# Modification Recommended Service Note

## N9000B CXA Signal Analyzer

### Password for Instrument Account Expires After 42 Days

Figure 1. Computer Management Dialog

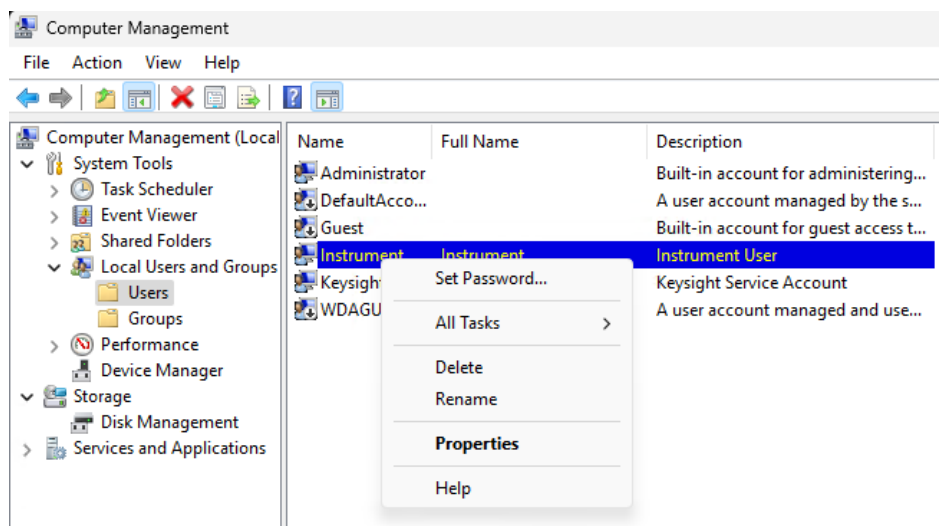
1. Connect a USB keyboard and USB mouse to two of the front-panel USB connectors
2. Log in as Administrator (default password: Keysight4u!)
3. Right-click on Windows icon and select Computer Management
4. Open System Tools, Local Users and Groups
5. Select Users
6. Right-click on Instrument and select Properties. See Figure 1 below.

Figure 2. Instrument Properties Dialog

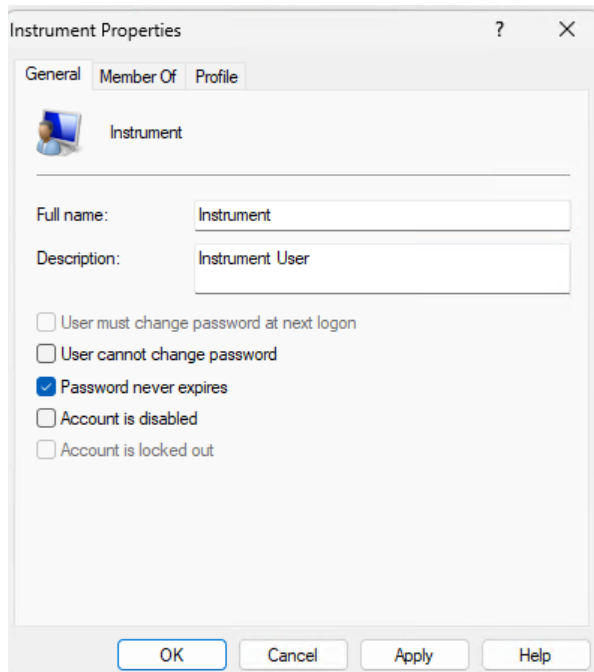
7. In the Instrument Properties dialog box, uncheck “User must change password at next logon”.
8. In the Instrument Properties dialog box, check “Password never expires”. See Figure 2 below.

9. Click “Apply” and “OK”.
10. Close the Computer Management dialog.
11. Cycle power on the analyzer.
12. Confirm that the analyzer boots up directly into the Instrument account, without any prompts to change the password, and automatically launches the XSA application.
